**DEPARTMENT OF TRANSPORTATION
STATE OF GEORGIA**

SUBJECT PROJECT CONCEPT REPORT APPROVAL

PROJECT NO. HPP-000-00(265)

INTERSECTION IMPROVEMENTS
HARDSCRABBLE ROAD AT CHAFFIN ROAD

CITY OF ROSSWELL
 TYPICAL SECTIONS
 PROJECT NO. 1598115
 DATE 8/28/00 DWG NO. 3-01

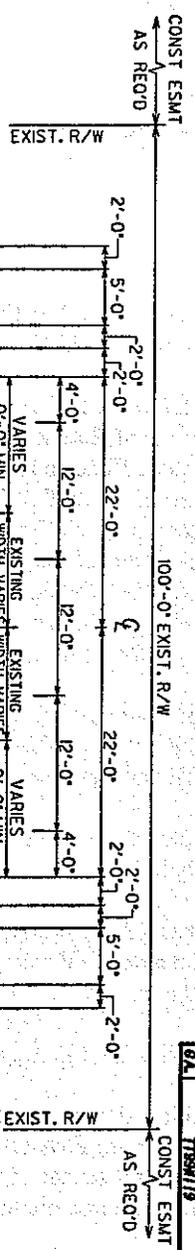
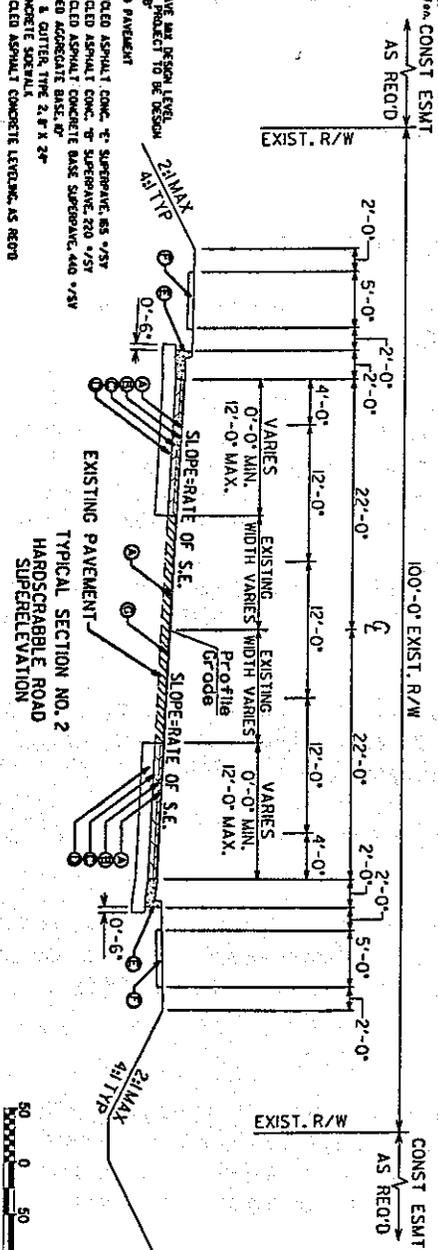
It was noted that the planned three-lane section would not increase the capacity of the roadway. The slope control table should be revised to a 4:1 slope in all fill sections.

Typical section should use 9.5 mm mix for asphalt surface course. The typical sections will be revised to remove any unnecessary notes and/or tables that are illegible.
